**Date:** 4<sup>th</sup> June 2002  
**Client:** Good Technology  
**Project Number:** GDTB-G100-SAR-3879  
**Contact:** Louie Sanguinetti  
**FCC ID:** PX3G100

Below is the response to the questions from the FCC in respect to the G100 portable device.

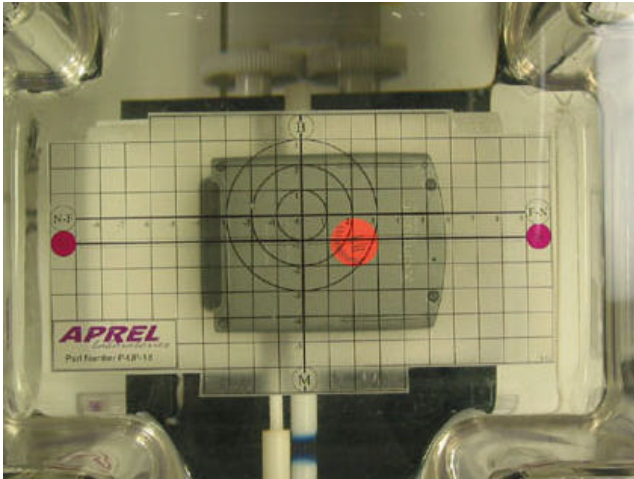
**1) *Need external photos with side views of device in holster please. Manual does not show holster option?***

Below is a side view of the device located in the holster.

Top View No Holster

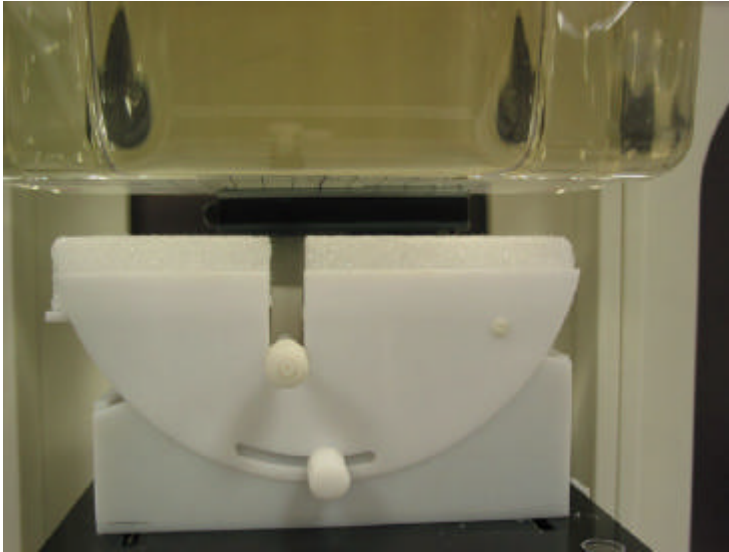
- 2) ***Need photos of EUT holder and setup with device in place as used for SAR test.***

Below are the views of the device while set-up for the SAR tests.
